WATER QUALITY MEMORANDUM

Utah Coal Regulatory Program

RE: Second Quarter of 2015 Water Monitoring, Genwal Resources, Inc., Crandall Canyon Mine, C/015/0032 Task ID #4912

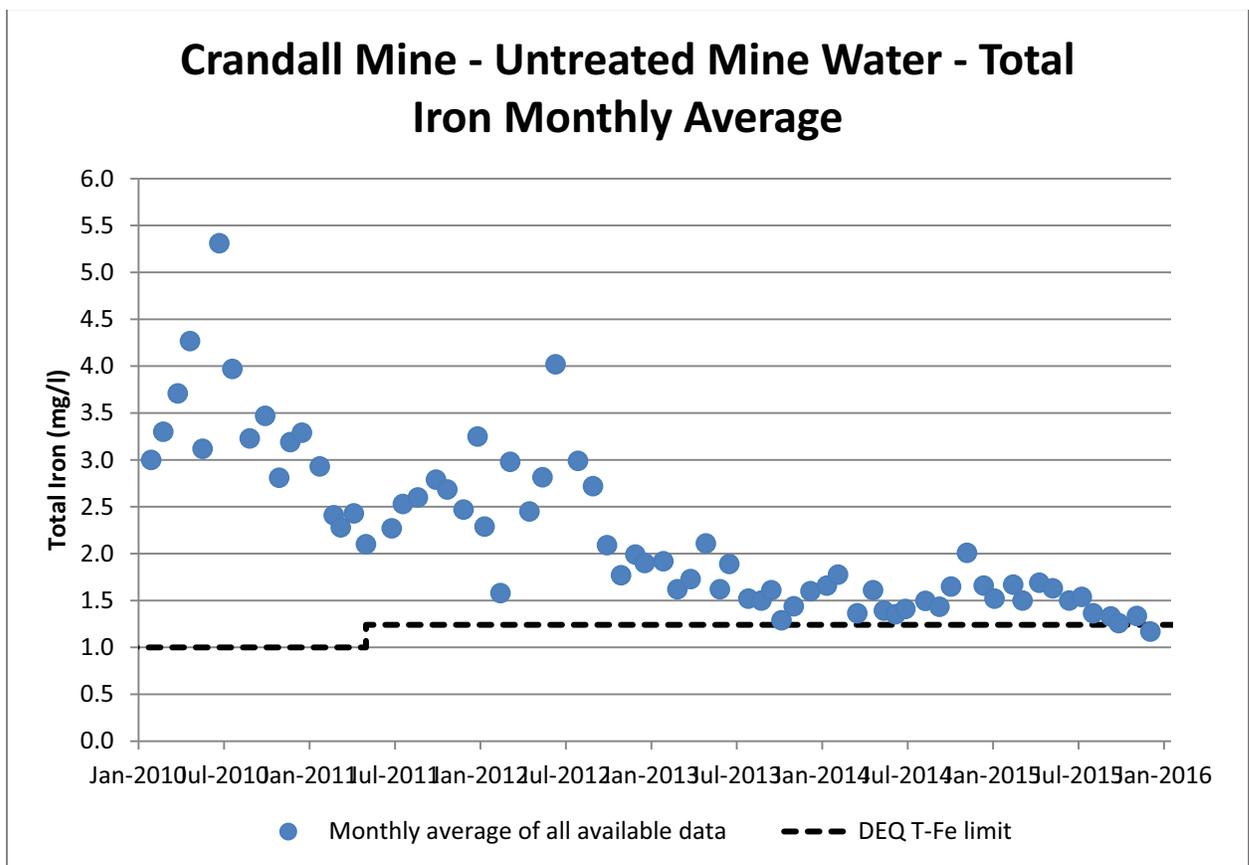
The total iron concentrations in the pre-treatment mine water remains above the 1.24 mg/L UPDES limit. Based on three sampling events the resulting concentrations for total iron were 1.82, 1.63 and 1.52 mg/L. The data show that total iron concentration still remains variable but since January 2010 to June 2014 a downward trend occurred. Beginning in fall 2014 though, we have seen a greater variability of data, and a slight increasing trend. Beginning in early 2015 we have begun to see the data tighten up, but remain, on average, between 1.5 and 1.7. Residual polymer testing was conducted by SGS laboratory and determined a level of residual flocculent of 0.13 mg/L in April, 0.21 mg/L in May and non-detect in June. Below is a graph of the pretreatment total iron concentration shown as a monthly median since January 2010.
